**TOWN OF NEWBURGH
PLANNING BOARD
TECHNICAL REVIEW COMMENTS**

PROJECT: MEADOW HILL ROAD EXPANSION
PROJECT NO.: 2016-07
PROJECT LOCATION: SECTION 60, BLOCK 1, LOT 9.1 & 9.2
REVIEW DATE: 12 MAY 2016
MEETING DATE: 19 MAY 2016
PROJECT REPRESENTATIVE: JCM ENGINEERING

Client:	MT	Approval:	JS
Scale:	NOT TO SCALE		
Date:	05/06/2016		
Project No.:	16015		
Job No.:	OWNER	OWNER	OWNER
Drawing:	SP-1

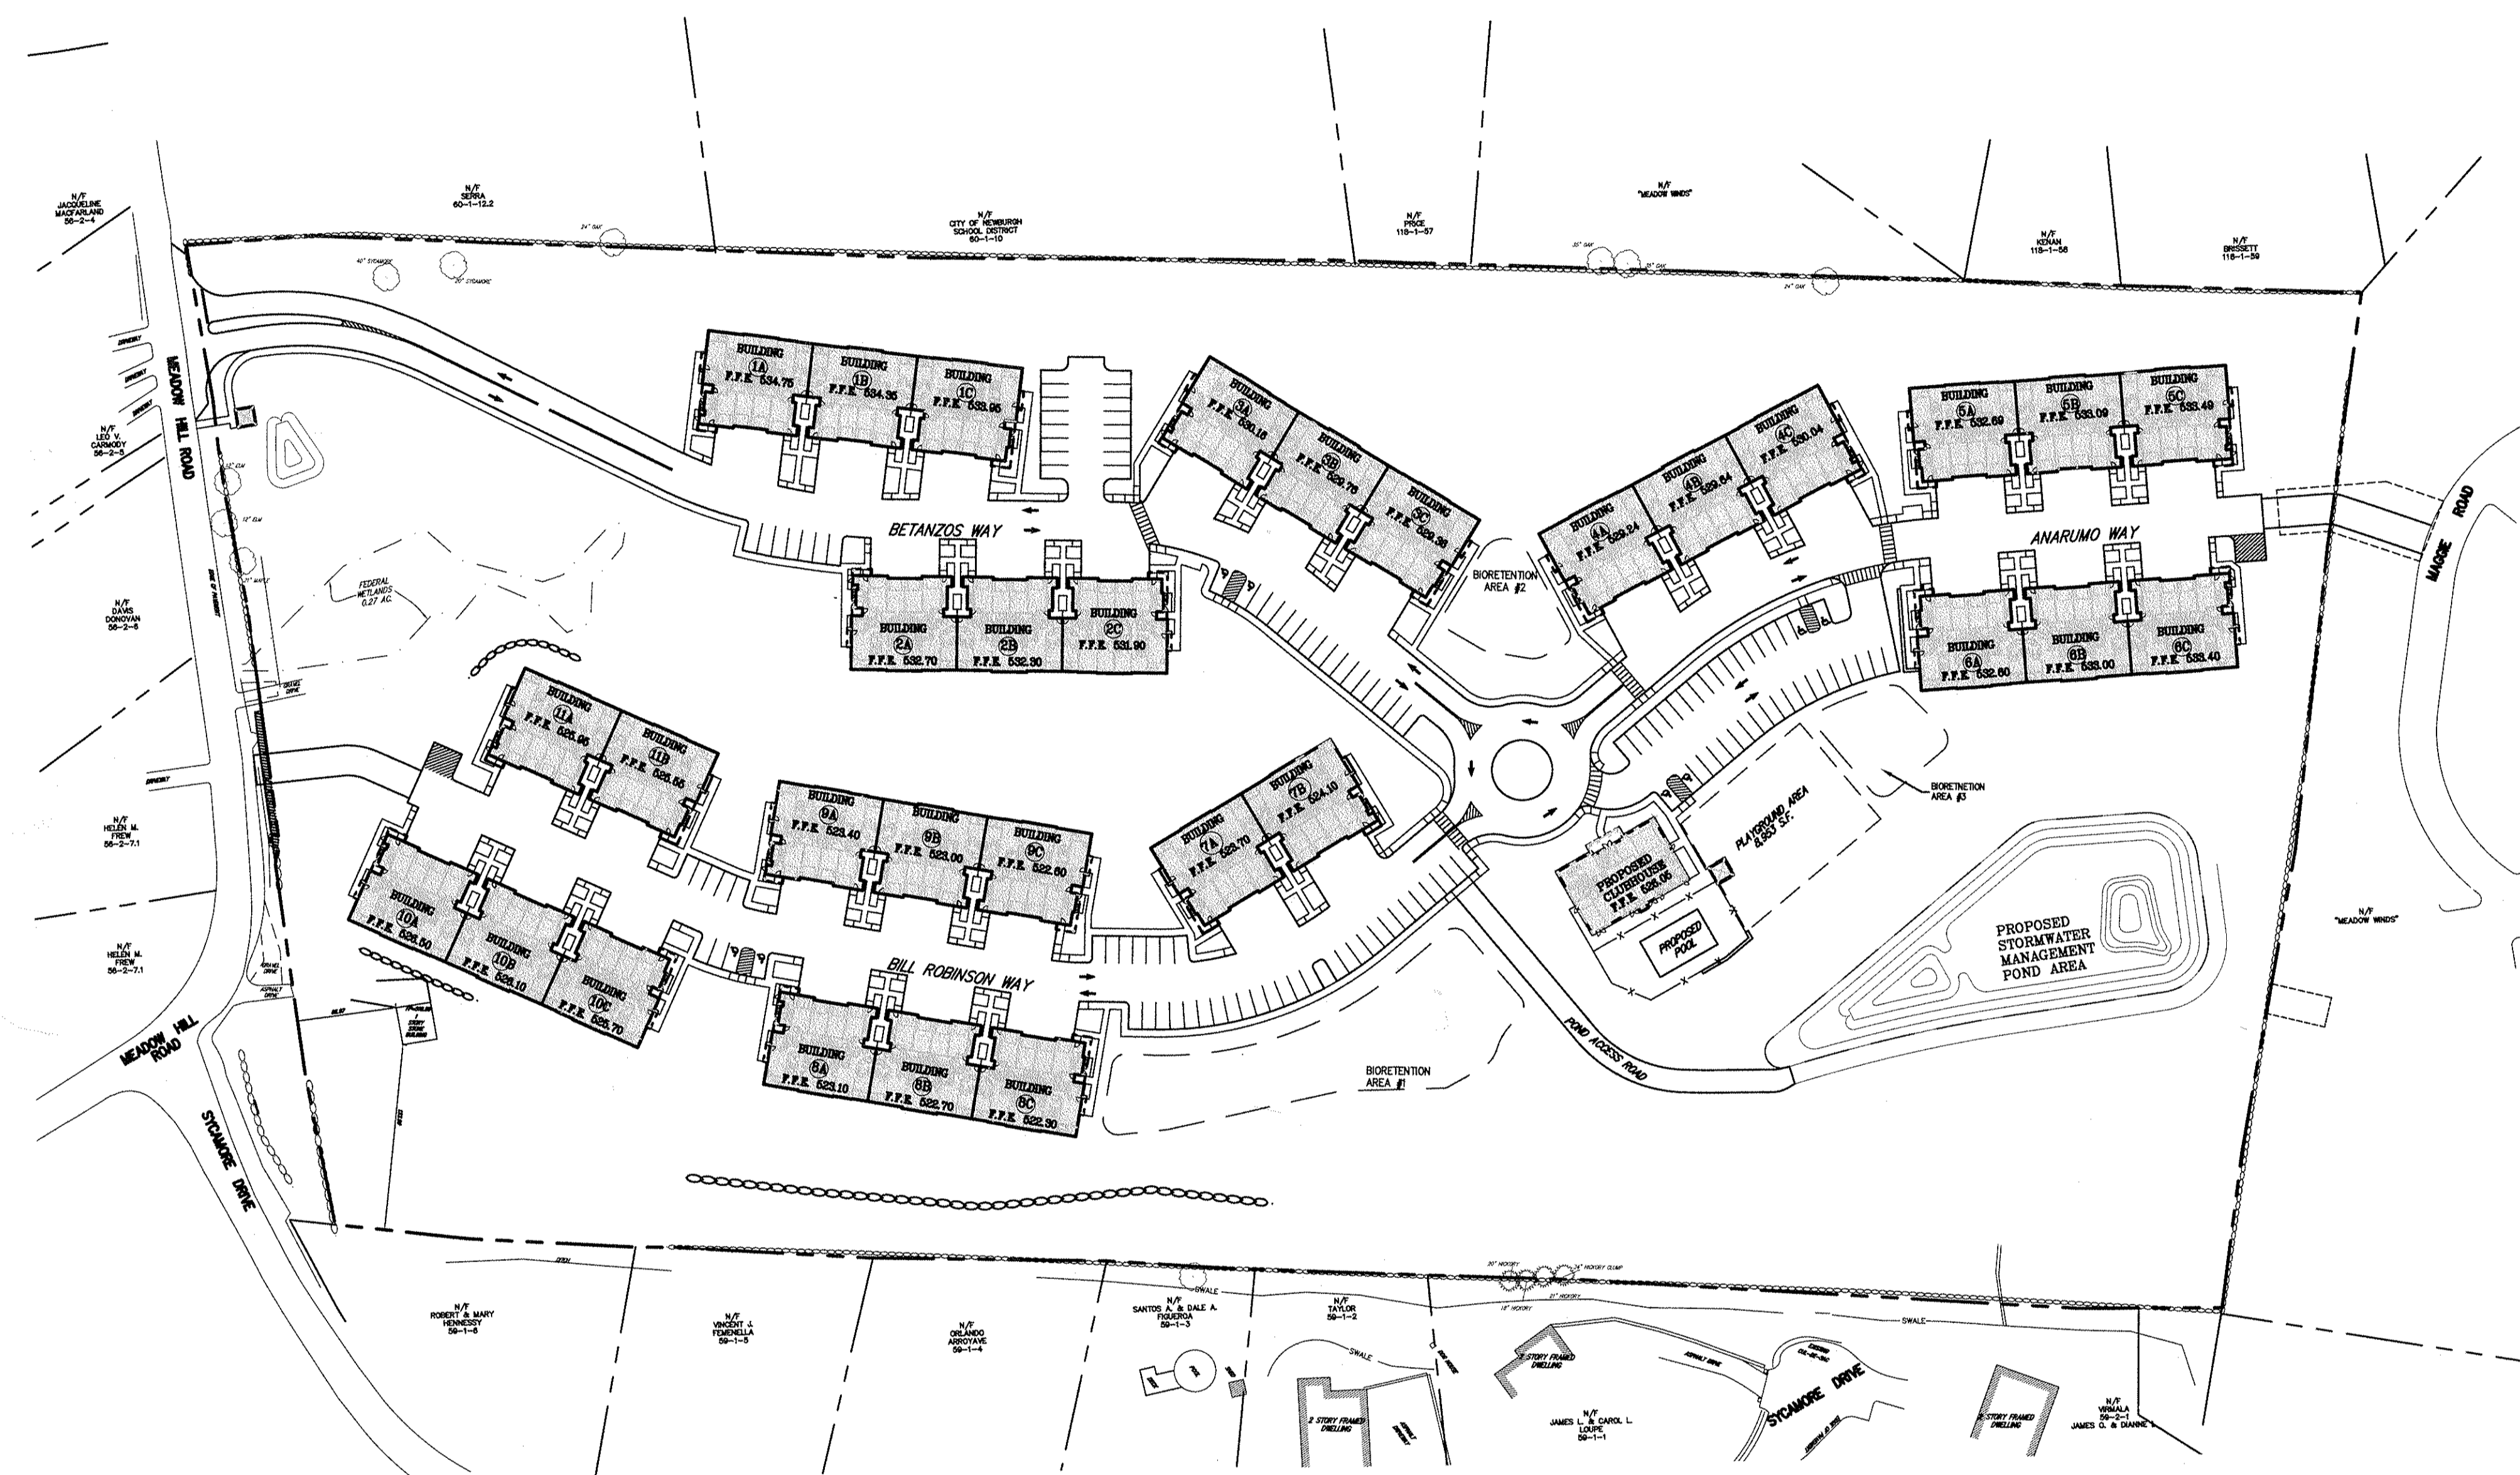
2. Note 8 on the cover sheet should be revised. Deferral of recreation fees has lapsed.
3. Lot consolidation will be required. The Applicant's representative should discuss timing of the lot consolidation.
